ADDENDUM NO. 3 - REVISED
CLASSROOM ADDITION TO LINCOLN HIGH SCHOOL
Architect Job No. 22-20
March 09, 2023
DCM # 2023129
Bid Number 1745

The Plans and Specifications are hereby amended. The following supersedes all contrary and/or conflicting information and is made part of the contract documents.

JOB NO. 22-20
SHEET NO:
P2.1

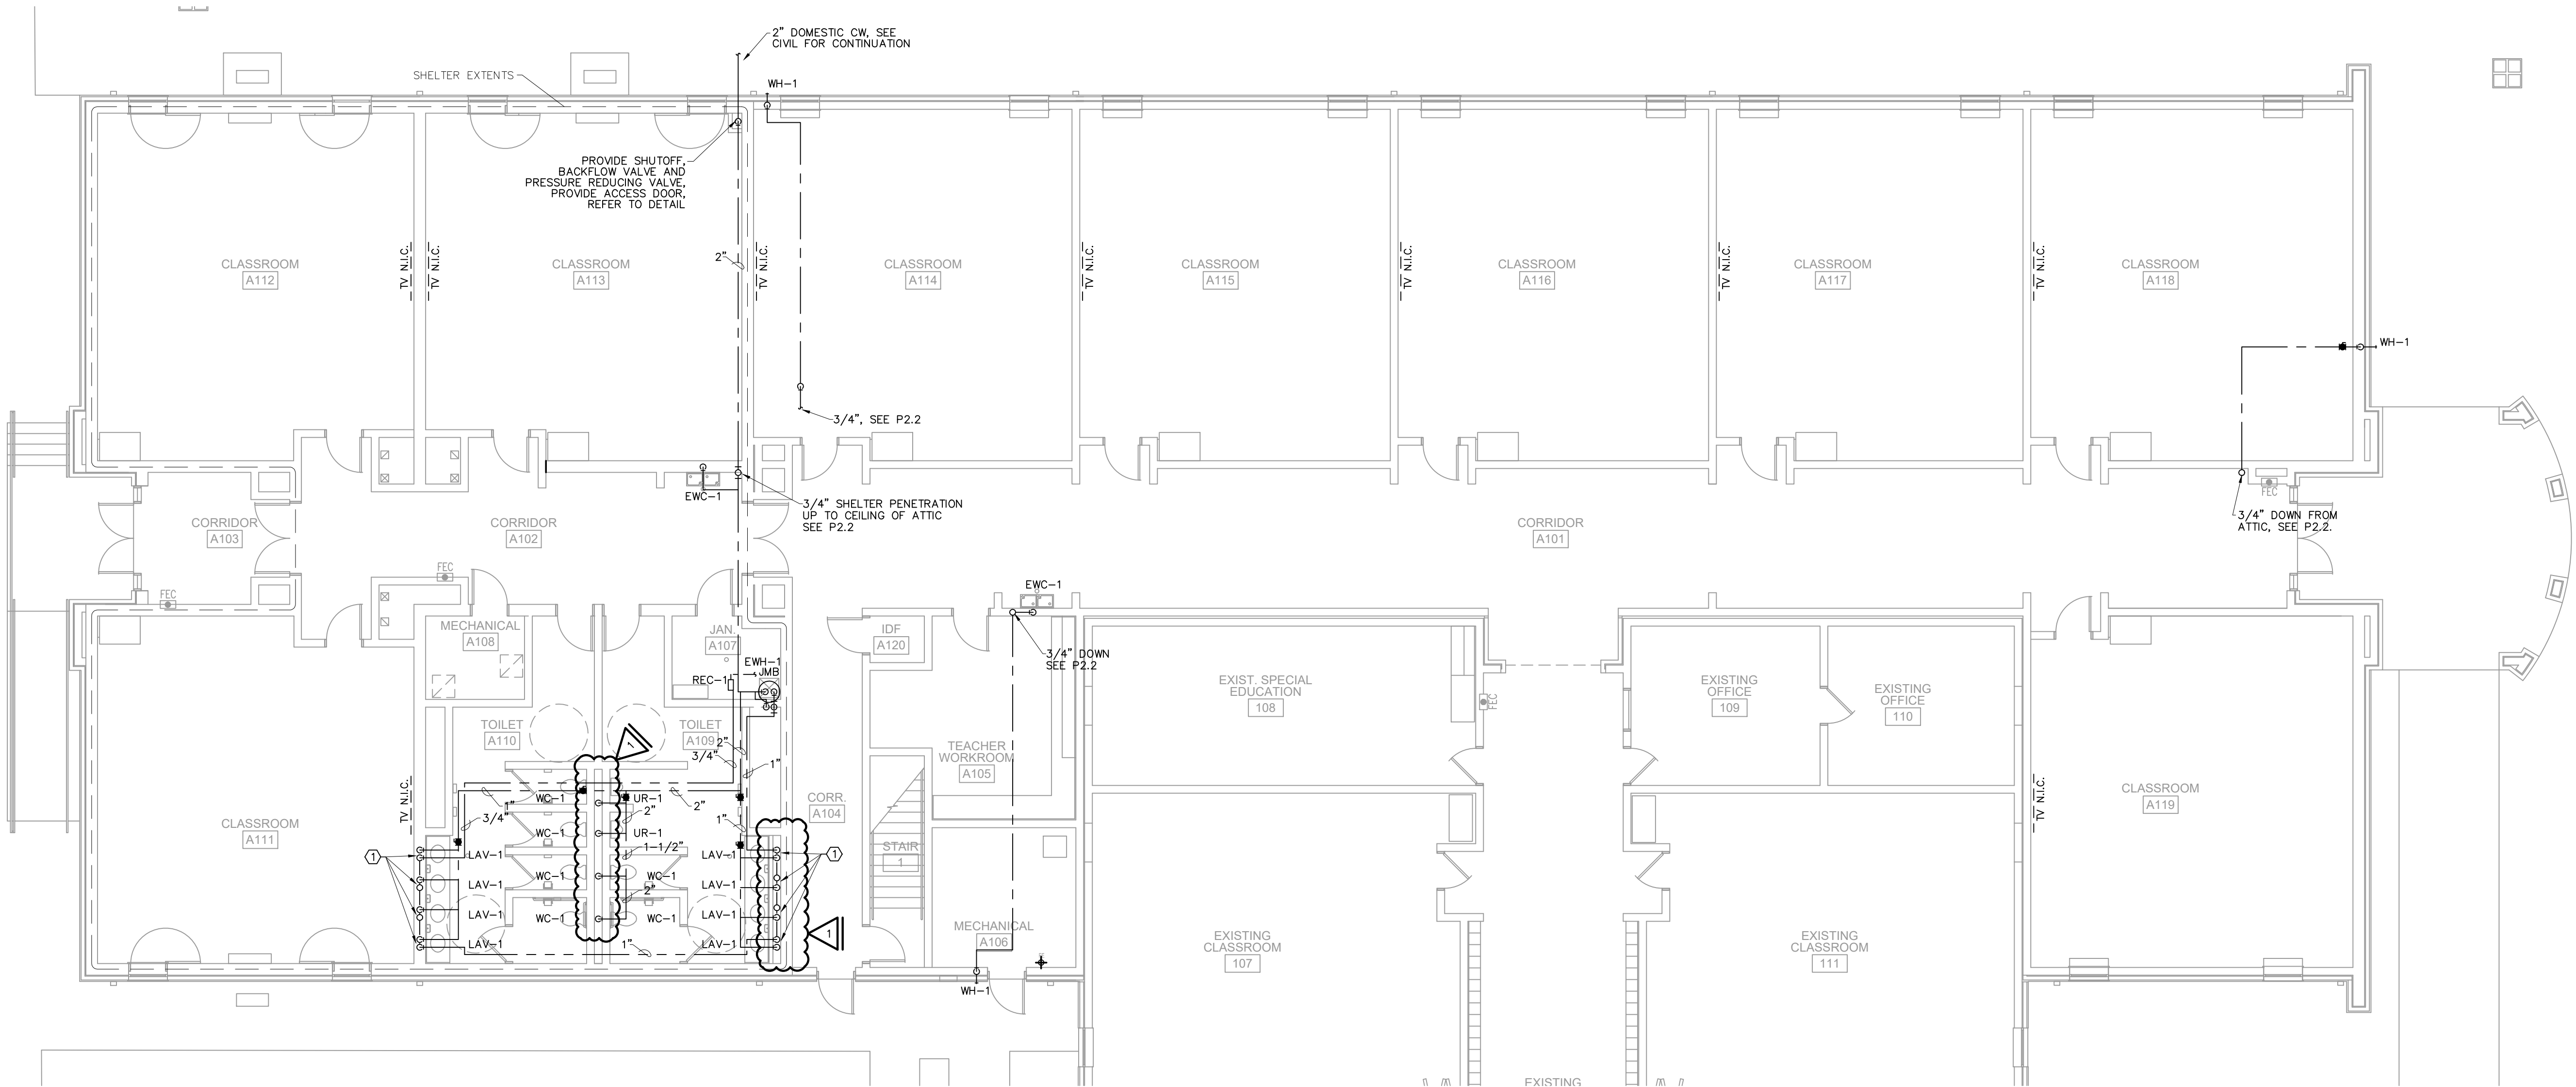
8. **P1.1, and P2.1** – for coordination revisions.
9. See attached **Sheet S1.0** – Steel allowance quantities in General Notes 7.18 & 7.19 have been revised based on quantities noted/stated in the project specifications.

S2.2

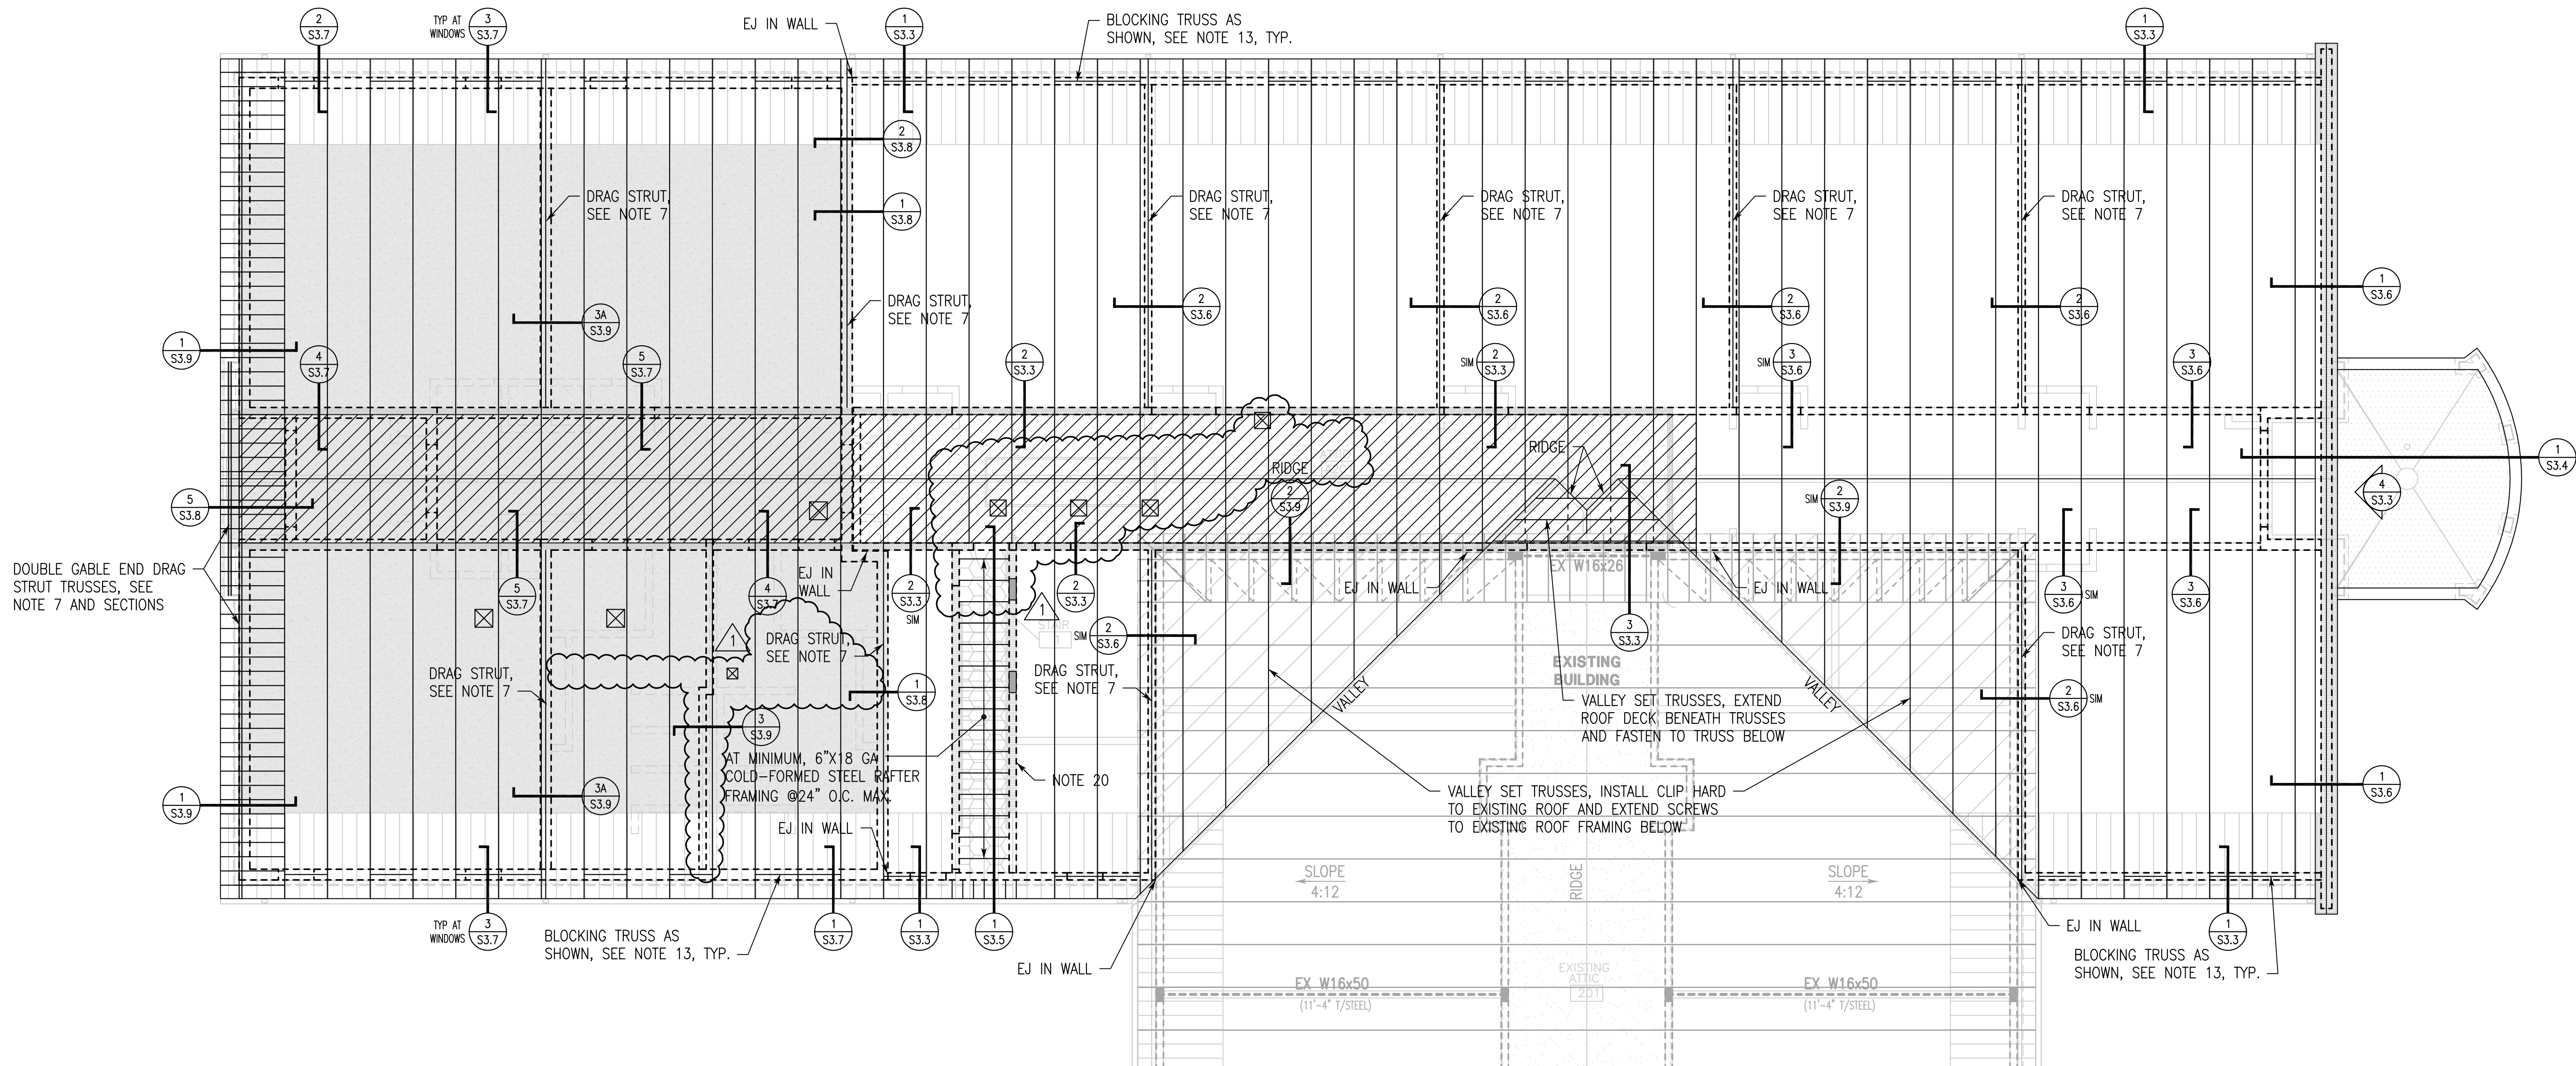
11. See attached **Sheet S2.2** – Layout revisions within the storm shelter as well as near/around IDF A120 have been made. Section cut at end of attic walkway has been revised based on pre-bid RFI response. Plan Notes 18-20 have been added and called out on the plan. Storm shelter roof shading has been corrected.

JOB NO.	22-20
SHEET NO:	S3.10
19 OF 19

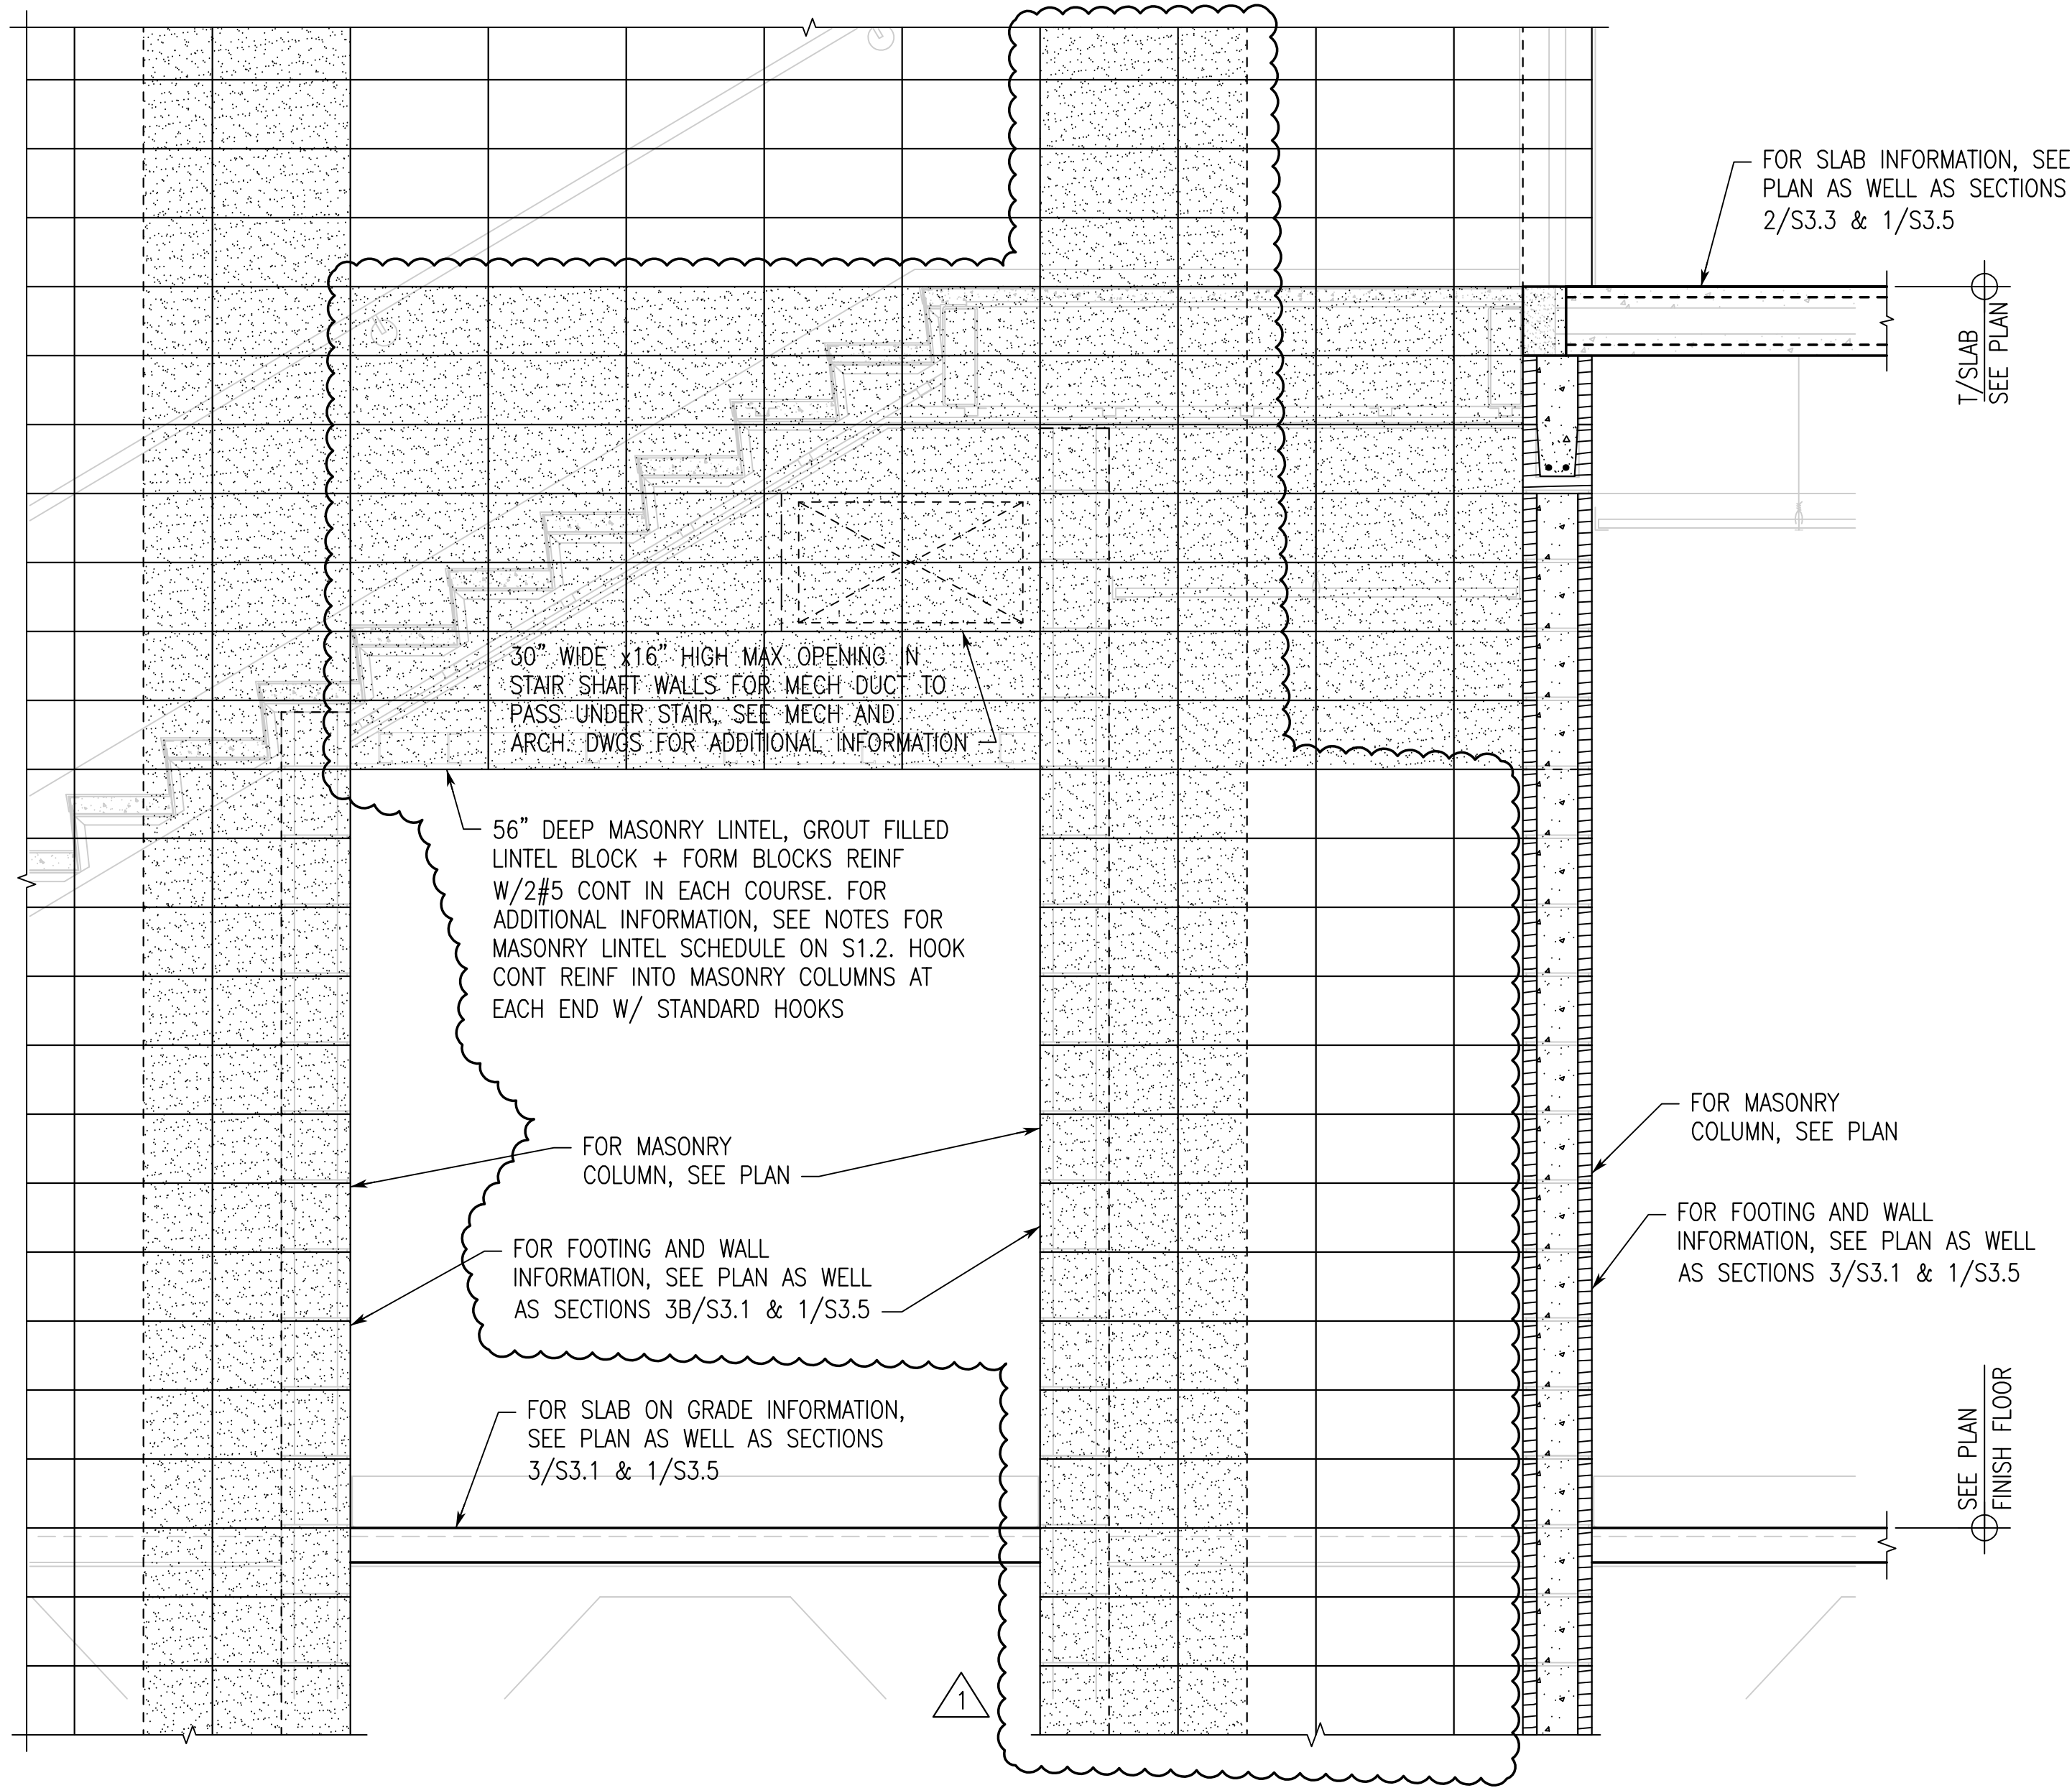
15. See attached **Sheet S3.10** – New wall has been added to frame out IDF A120 and section was revised accordingly. Approximate mech. duct penetration location has been shown.
